# Access Compliance Report

## Public Rights-of-Way

### (Curb Ramps)

Intersection ID: 3569	Main Street: OLYMPUS_DR	Cross Street: SHIMMERING LAKE_DR	Location: SE
ADA ID: A3CB96461323	Ramp Type: Perp	Initial Pass/Fail: Fail	Overall Compliance: No
Severity Score: 12.5			
Codes/Mitigation Info/Possible Solution		Field Measurements/Component Compliance

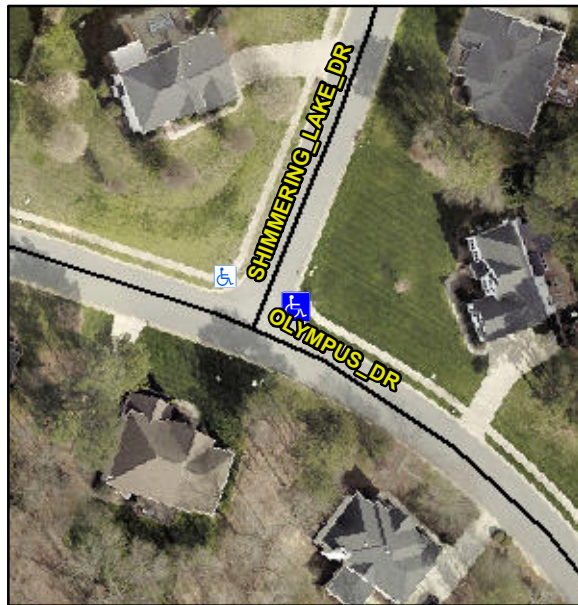
**Not Found, R304.2.2**

Compliance	Description	Data	Compliance	Description	Data
N/A	Ramp Length (in)	41.0	No	Ramp Slope (%)	8.7
Yes	Ramp Width (in)	56.0	Yes	Ramp XSlope (%)	2.0
N/A	Flare Type LT	N/A	N/A	Flare Type RT	N/A
N/A	Flare Slope LT (%)	N/A	N/A	Flare Slope RT (%)	N/A
N/A	Flare Traversable LT?	N/A	N/A	Flare Traversable RT?	N/A
N/A	Landing Length (in)	N/A	N/A	DWS Provided?	N/A
N/A	Landing Width (in)	N/A	N/A	DWS Contrast?	N/A
N/A	Landing Slope (%)	N/A	N/A	DWS Length (in)	N/A
N/A	Landing X Slope (%)	N/A	N/A	DWS Full Width?	N/A
N/A	Landing Curb? (Y/N)	N/A	N/A	DWS Offset (in)	N/A
N/A	Shared Landing?	N/A			
N/A	Gutter Ponding?	N/A	N/A	Gutter Slope (%)	N/A
N/A	Gutter Lip Ht (in)	N/A	N/A	Gutter X Slope (%)	N/A
N/A	Painted X Walk1?	No	N/A	Painted X Walk2?	N/A
	X Walk 1 Direction	To NW		X Walk 2 Direction	N/A
N/A	X Walk 1 Width (in)	N/A	N/A	X Walk 2 Width (in)	N/A
	X Walk 1 Slope (%)	1.9		X Walk 2 Slope (%)	N/A
	X Walk 1 X Slope (%)	0.9		X Walk 2 X Slope (%)	N/A

**Remove & Replace Entire Ramp.**
